## **ADDENDUM #2**

### **Rye City School District**

***Issued: 2021-02-05***

**This Addendum No. 2 forms part of the Contract Documents and modifies the original bidding documents dated, January 19, 2021.**

**SKP2-2**

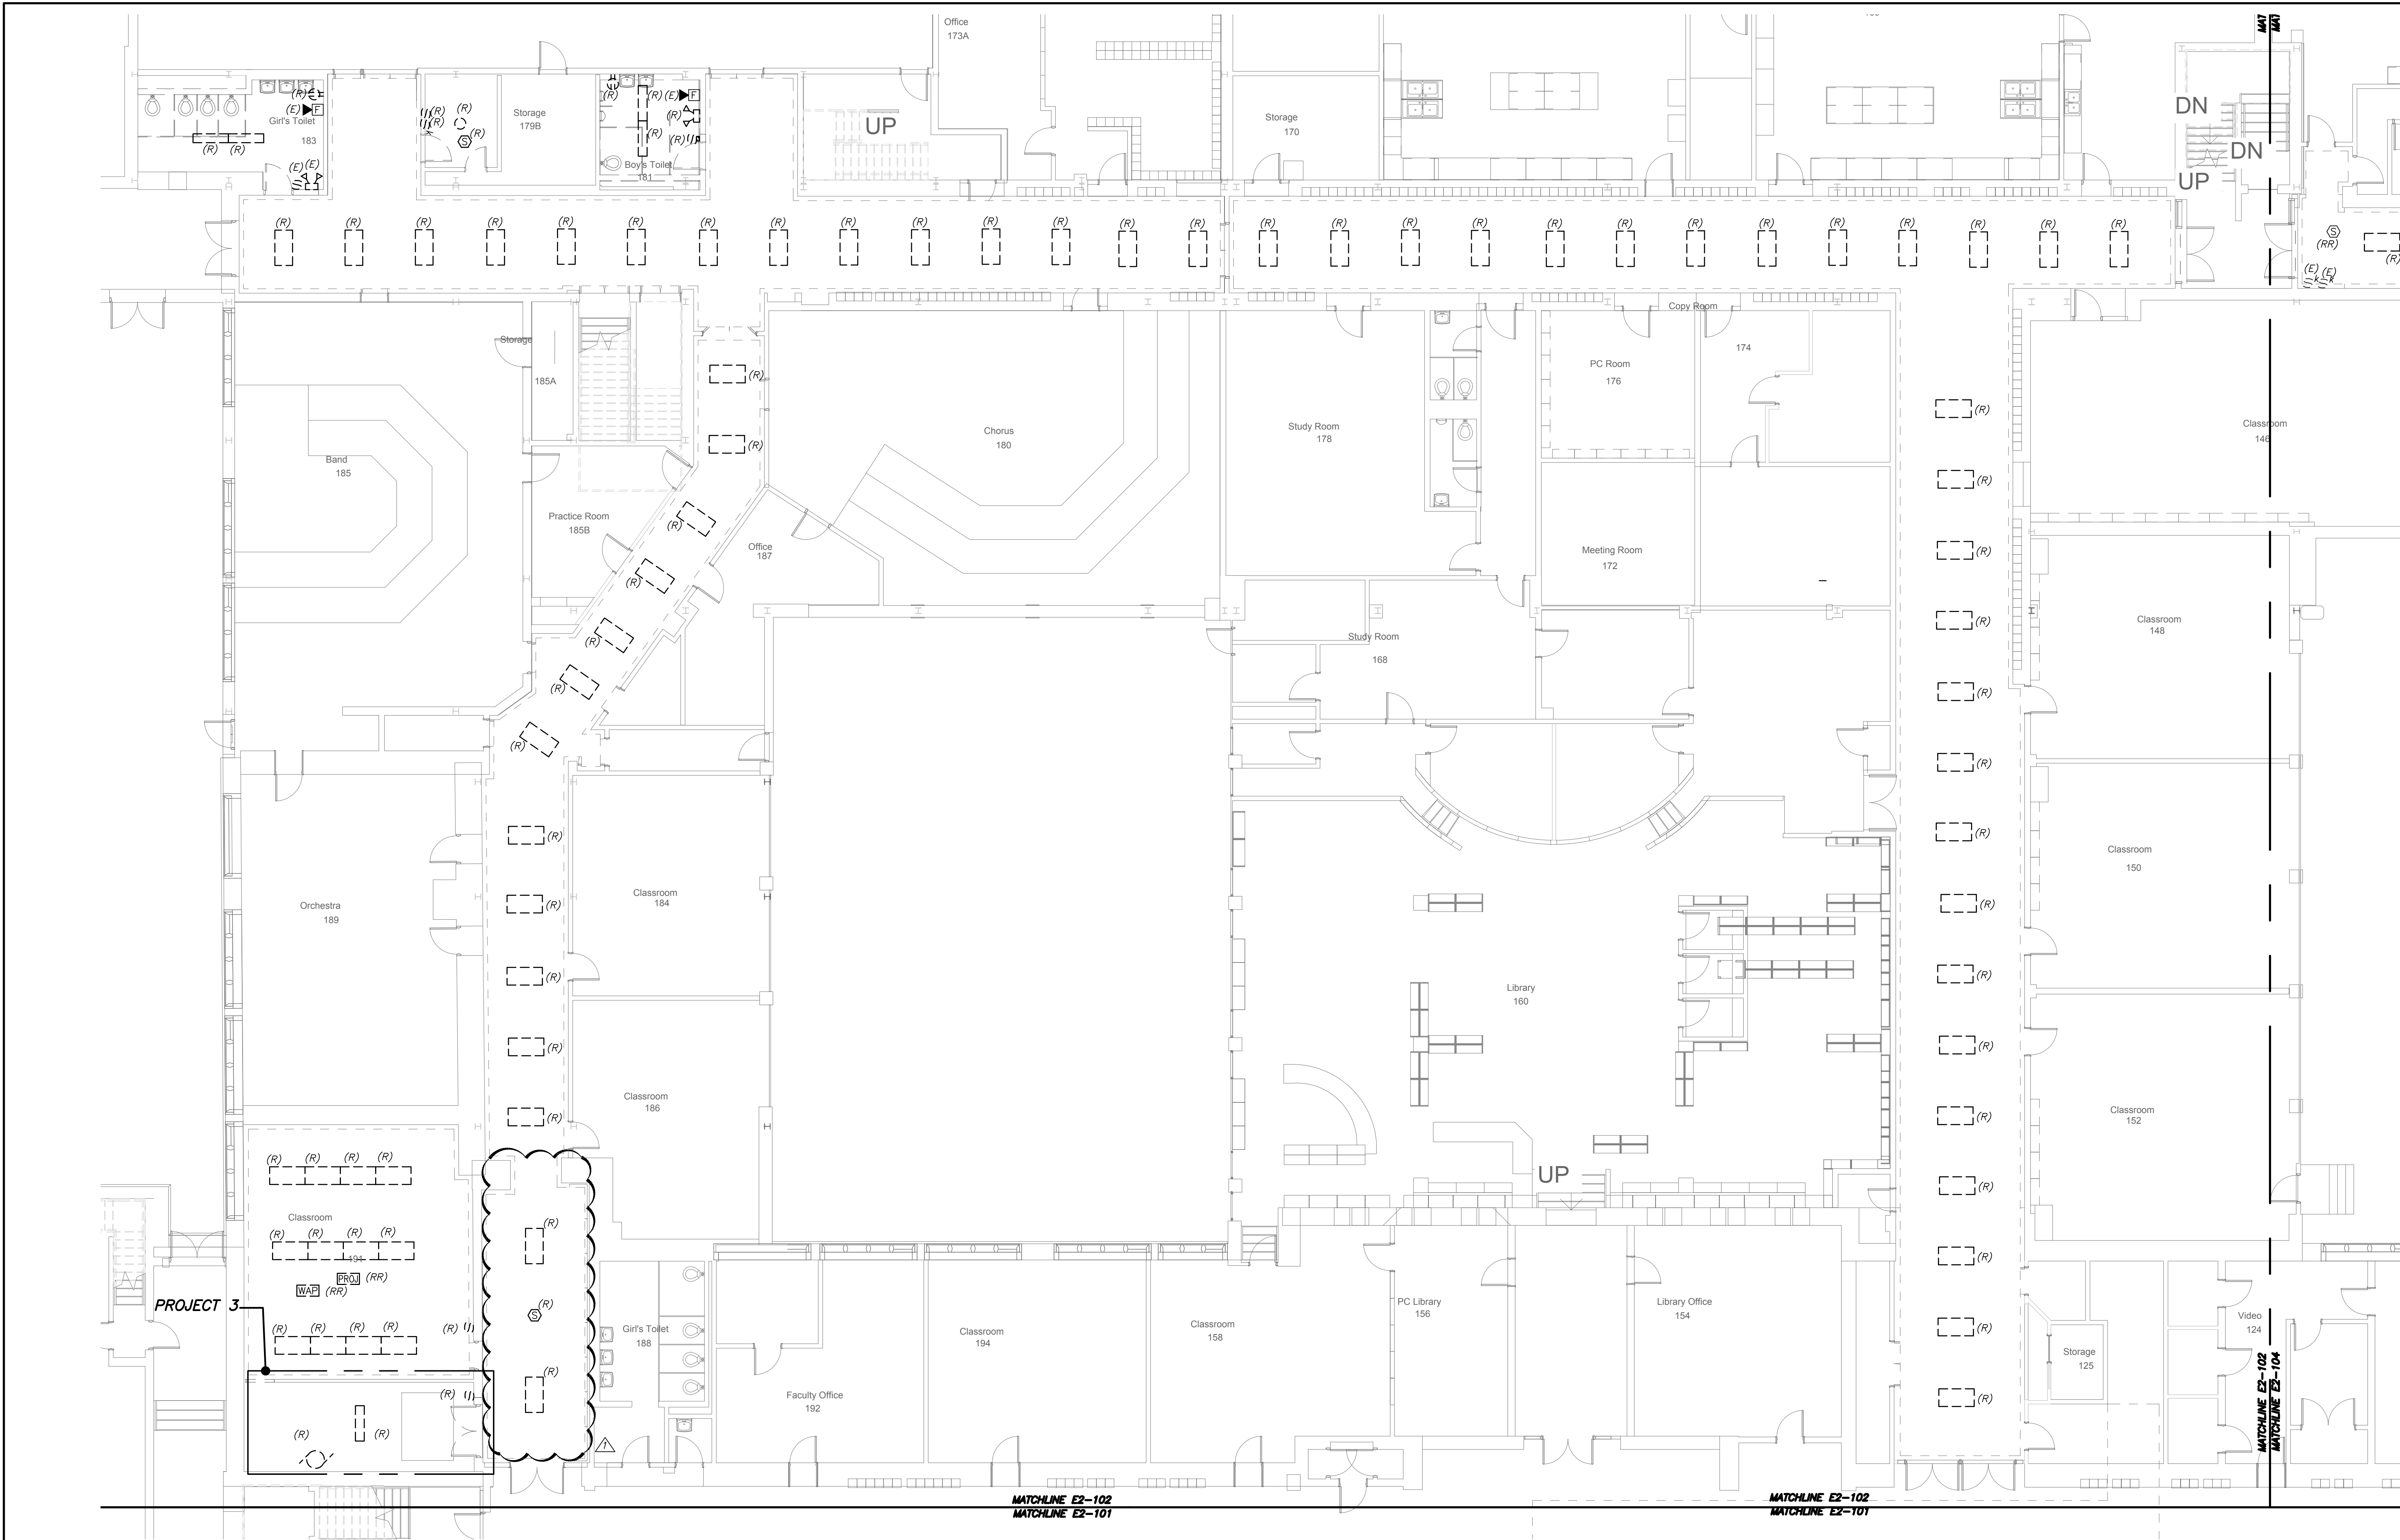
1. Drawing P2 – 101 Legend, Schedules, Notes, First and Second Floor Plans
  - a. Second Floor Plan 2/P2-101 (Removals) (Project 1).
    - i. Add note: “Included sink removal in Room 221A for second new electric room.”
2. Sketches SKP2-1 and SKP2-2
  - a. PRV Assembly Replacement as shown on sketches attached.

SEAL & SIGNATURE	DATE: 11/07/19
	PROJECT No: 9200
	DRAWING BY: BGA
	CHK BY: BGA
	DWG No: E2-108

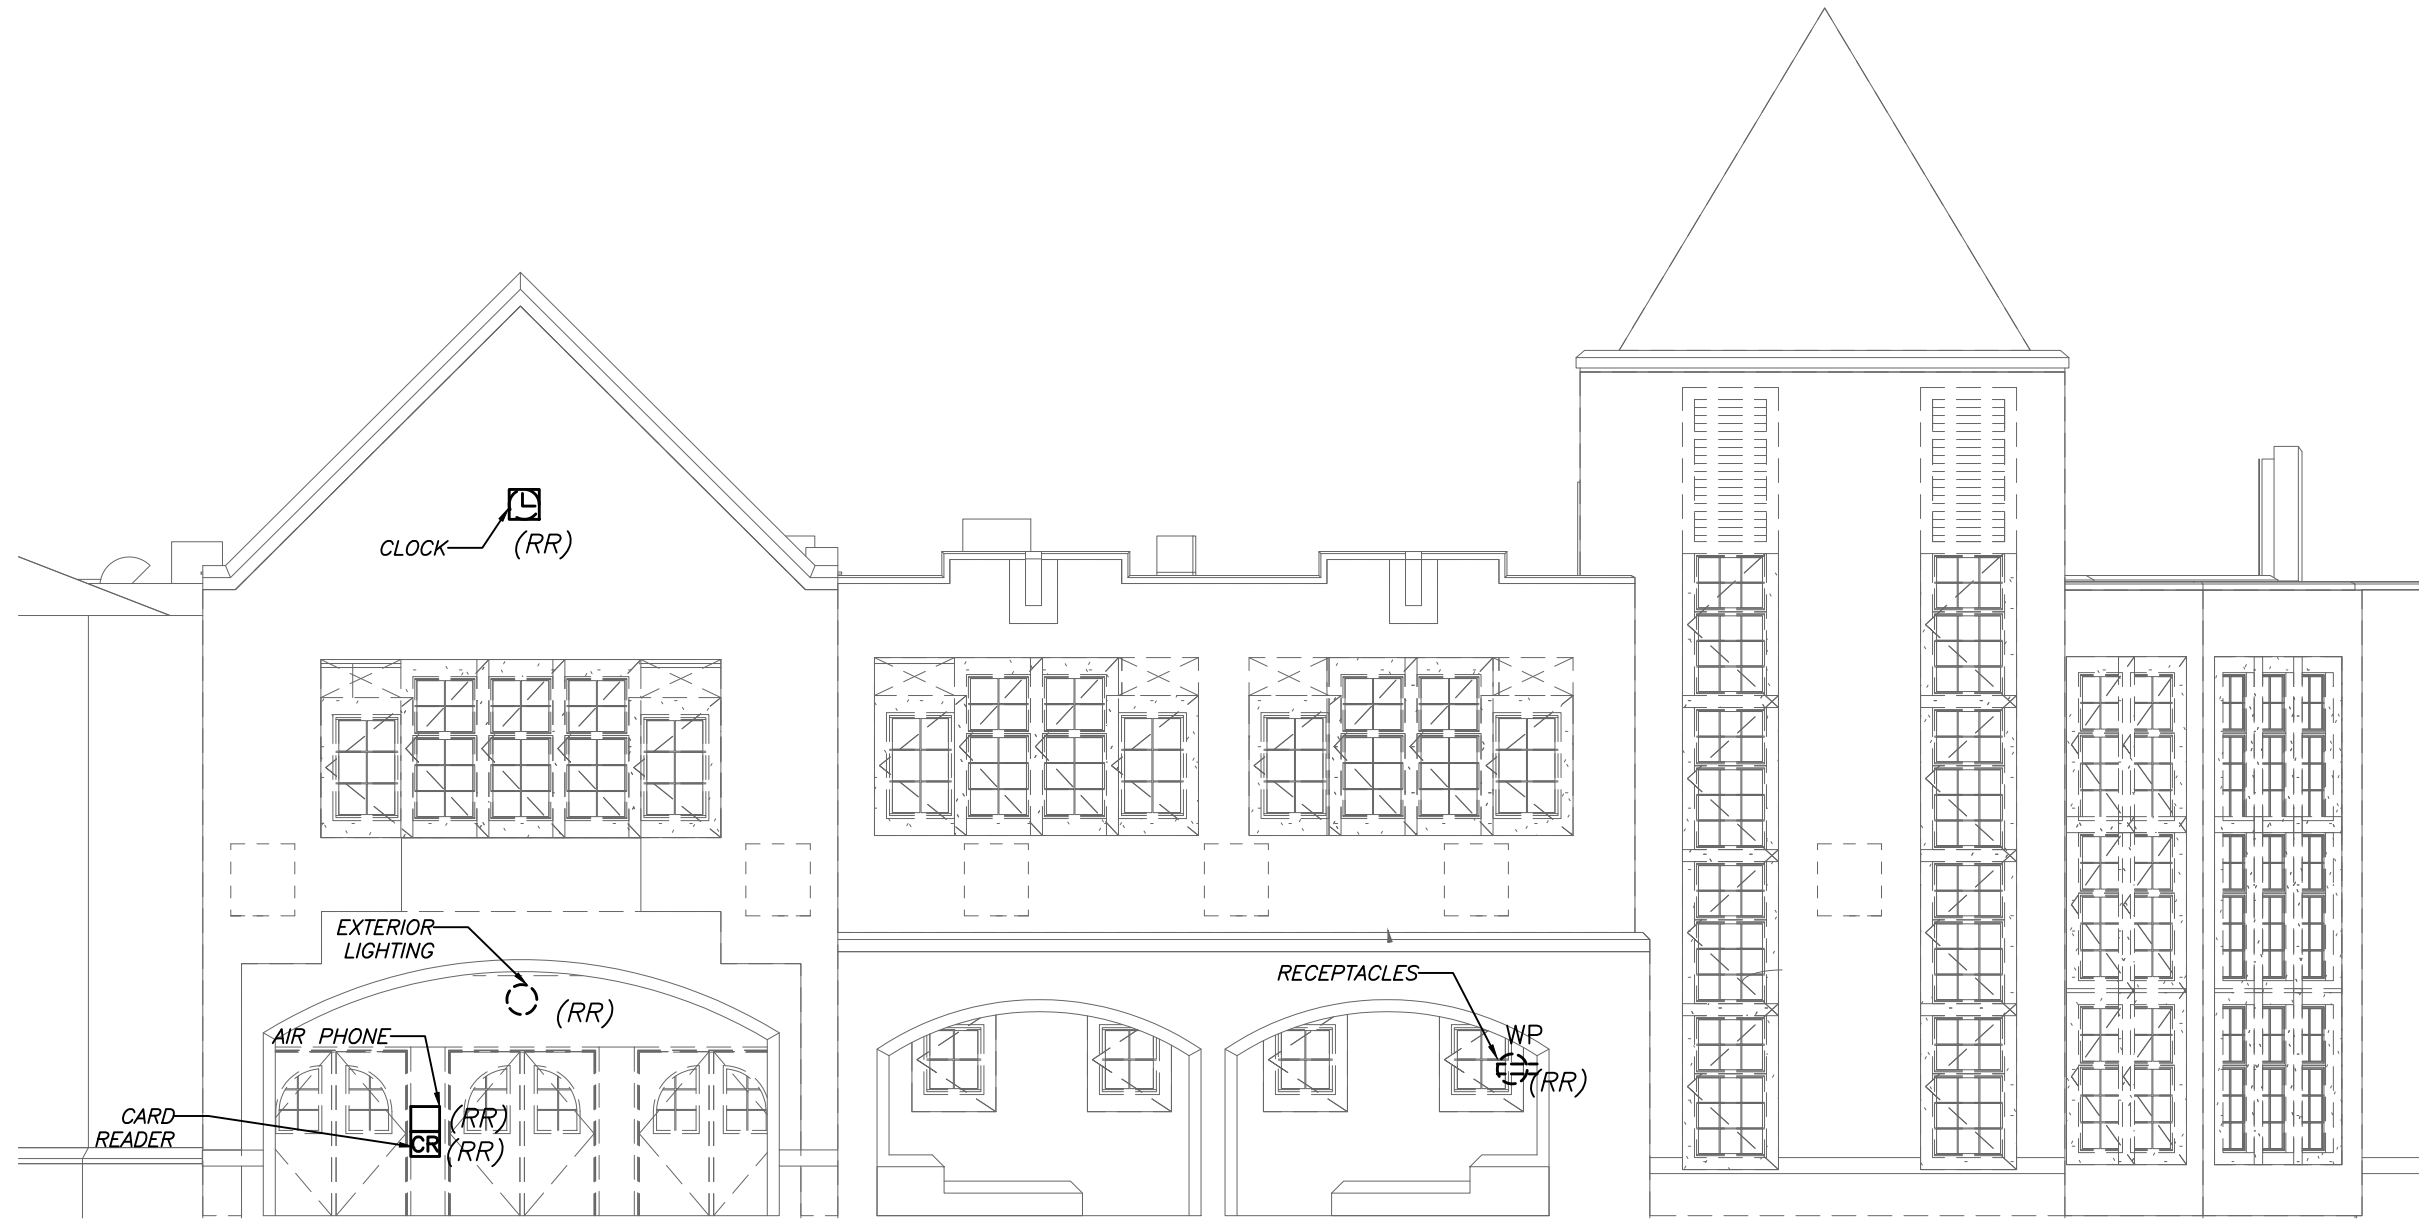
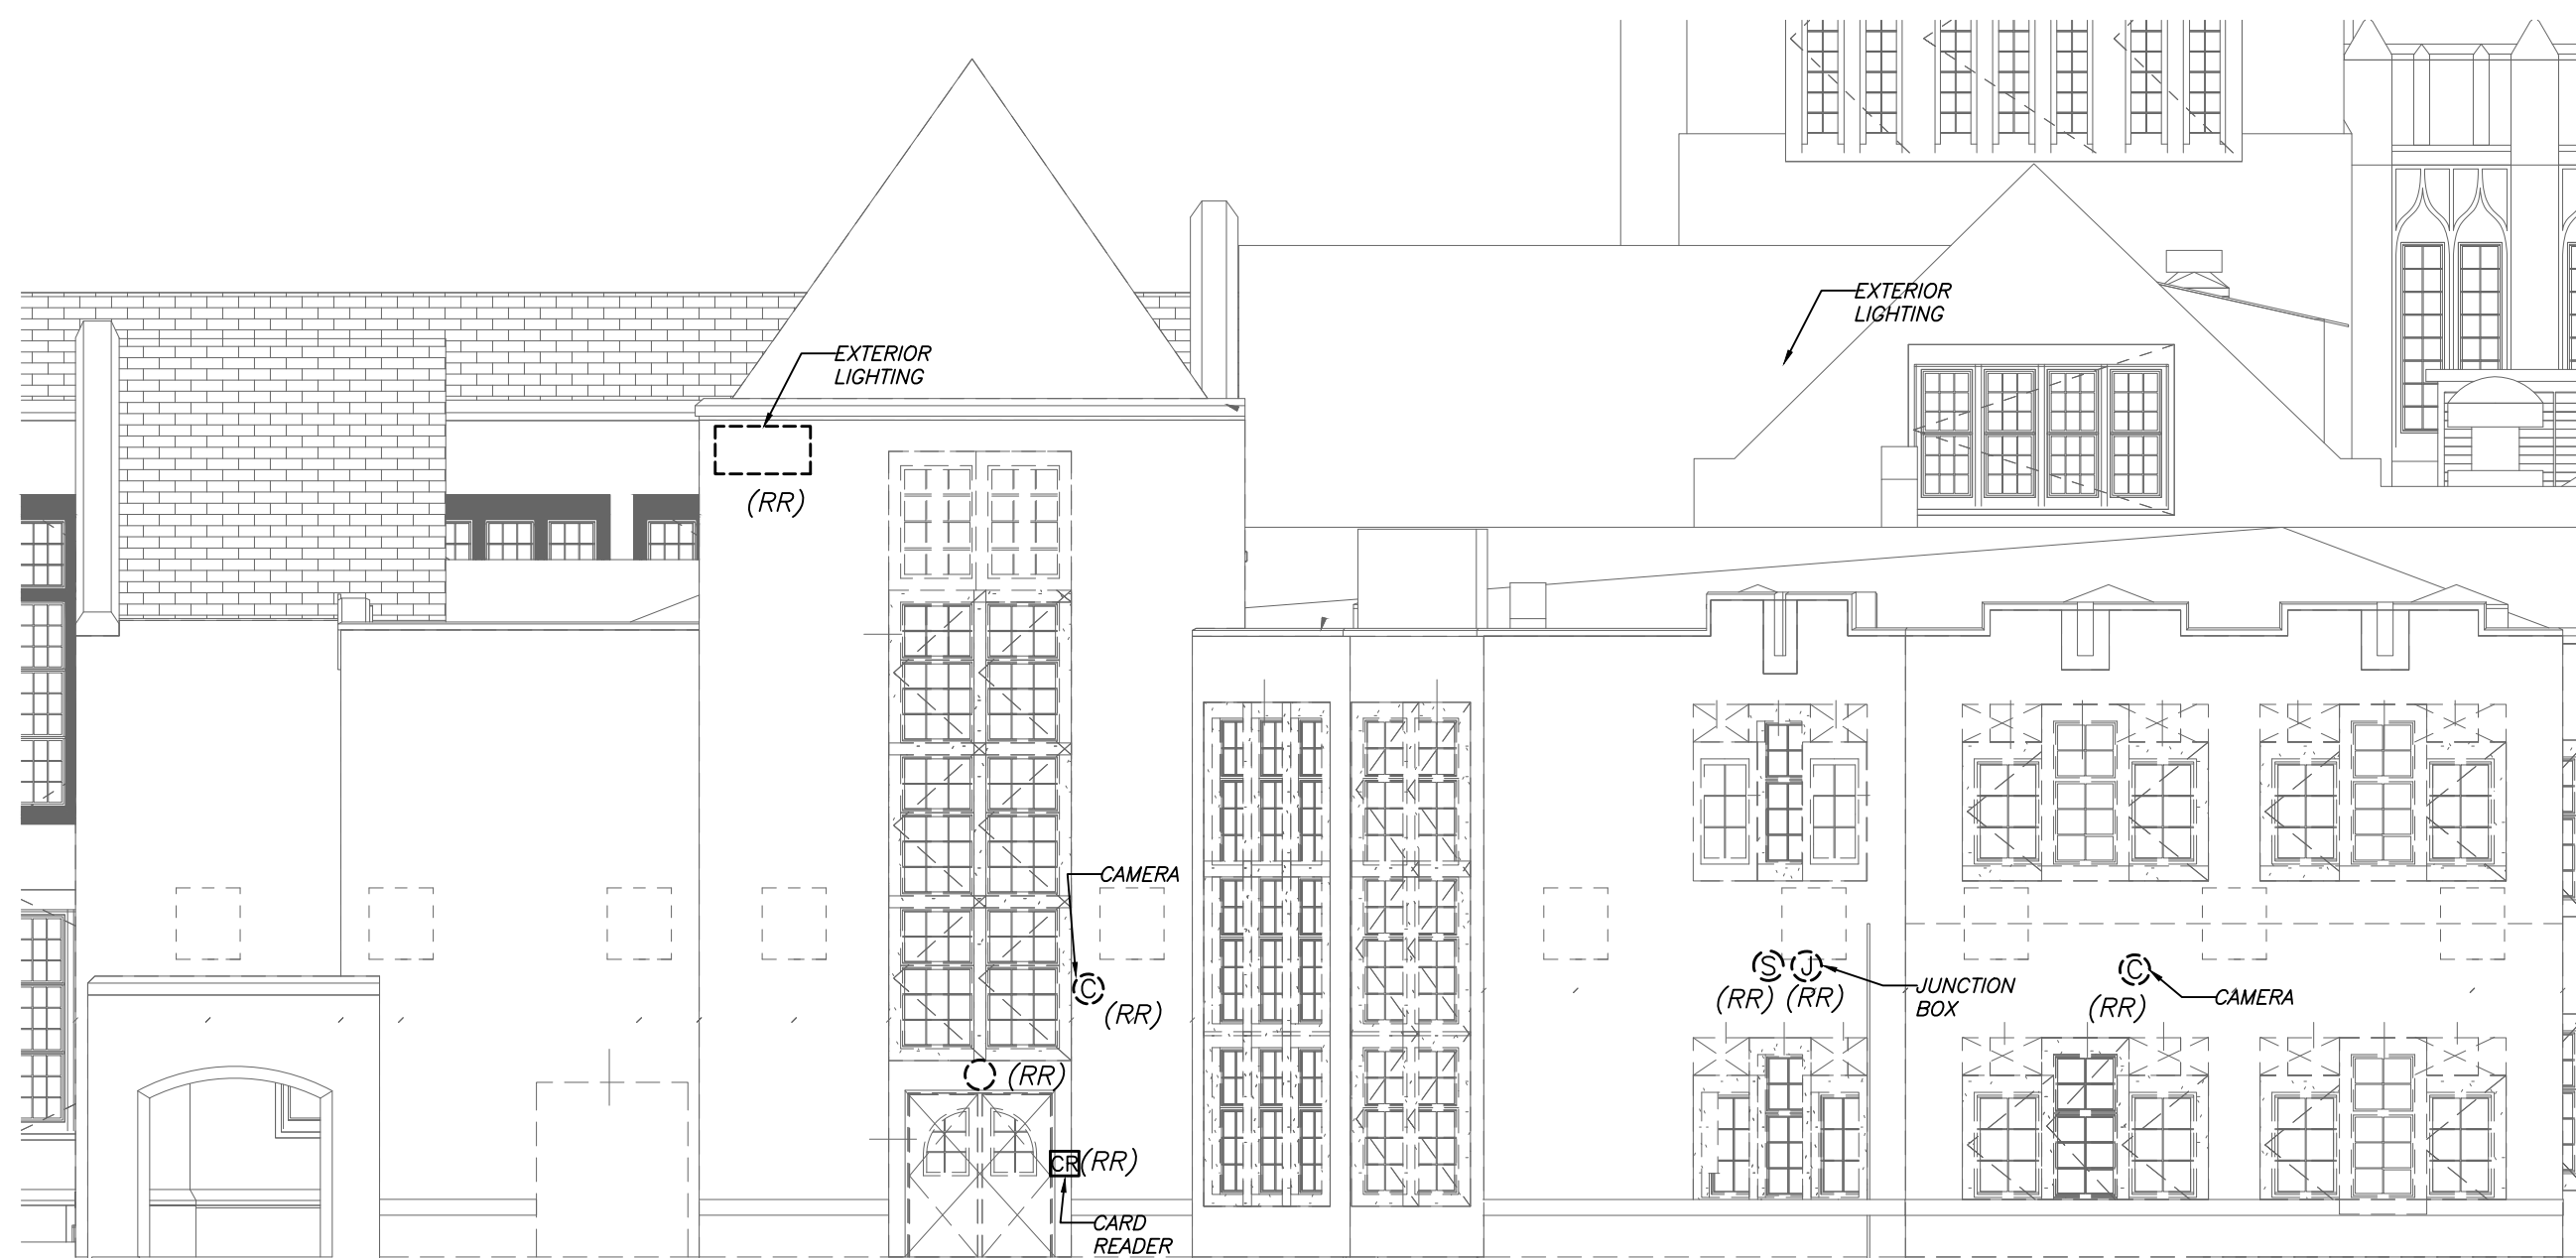
3. Drawing E2-106 Partial Second Floor Removal Plan
  - a. Revised to show electrical demolition of existing mechanical equipment.
4. Drawing E2-108 Exterior Removal Plan

- a. Revised to show Project 4 instead of Project 4A.
5. Drawing E2-201 High School & Middle School Part First Floor Lighting Plan
  - a. Revise High School vestibule lighting layout.
